MARKUP TO DESCRIBE LOUVERED / OBSCURED GLAZING STRATEGY

PLANNING

project title: MARLSBRO HOUSE MANCHESTER		
drawing title: Proposed Elevation Port Street	scale: 1:100 @A1	date: 30.07.26
	drawn by: PD	checked by: SC
drawing no.: AHA/MHM/PA/ 202	revision: B

1 PROPOSED PORT ST. ELEVATION
Scale: 1:100

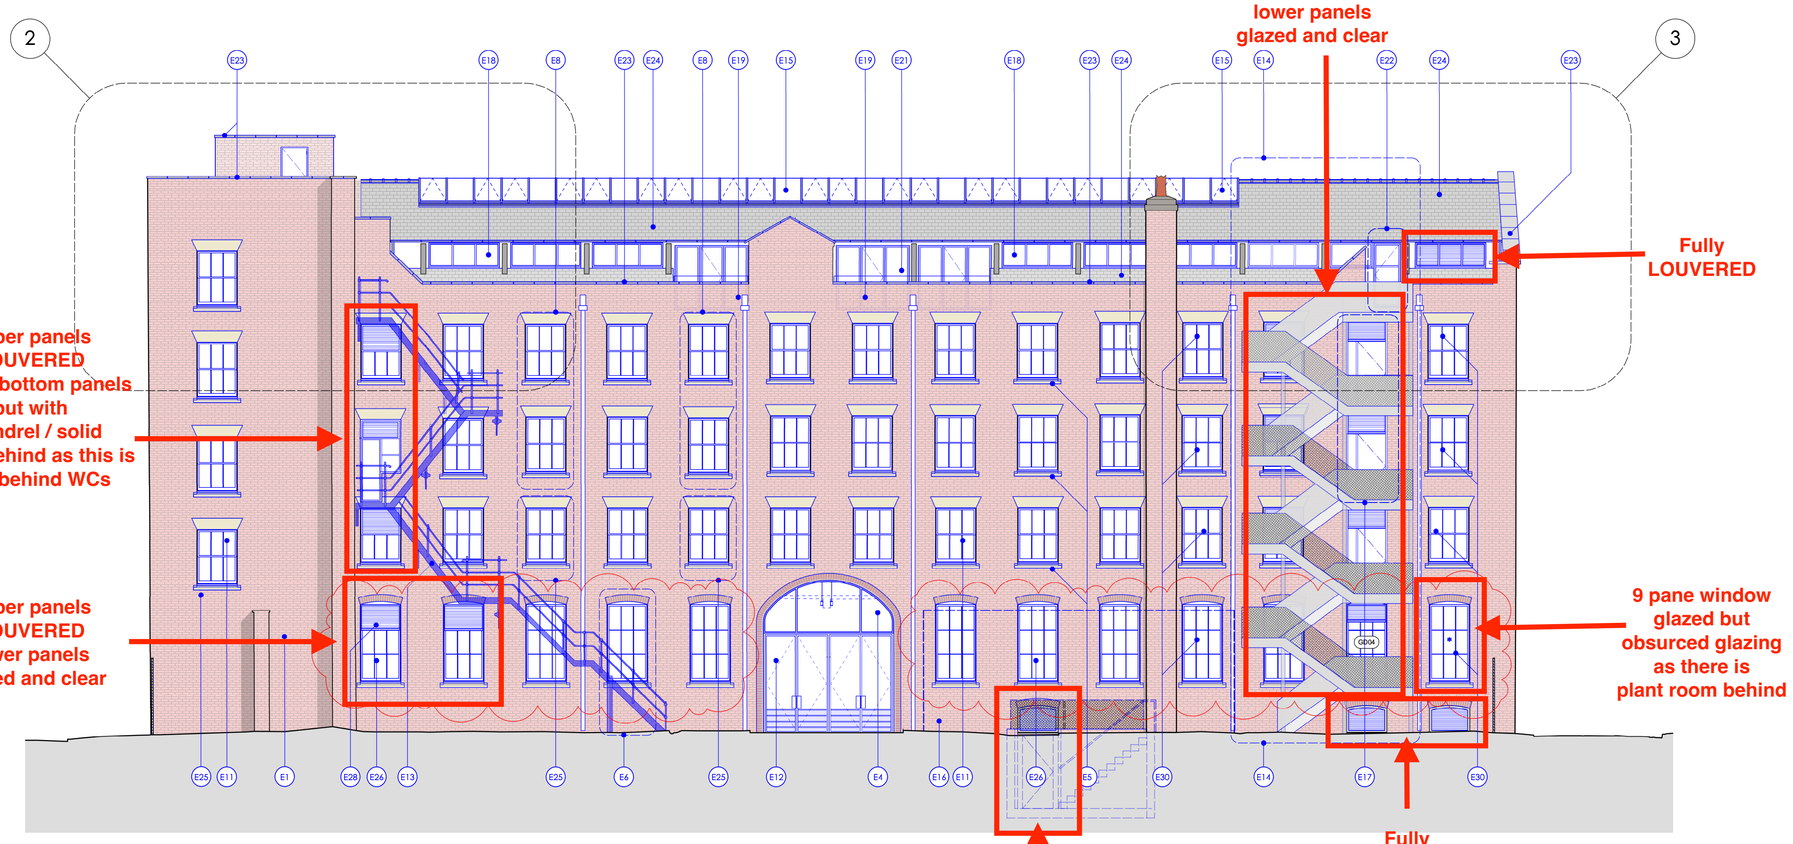
E27. New Timber framed 3 over 3 double glazed sash window, with 30min fire rating due to adjacentl staircase
E28. New Window /Door to match adjacent window, with high level partial louvers, see separate detail
E29. N?
E30. New Timber framed 3 over 3 double glazed sash window, with 30min fire rating due to adjacent staircase. Ground floor window with '*' is a spandral panel, due to plant room beyond.
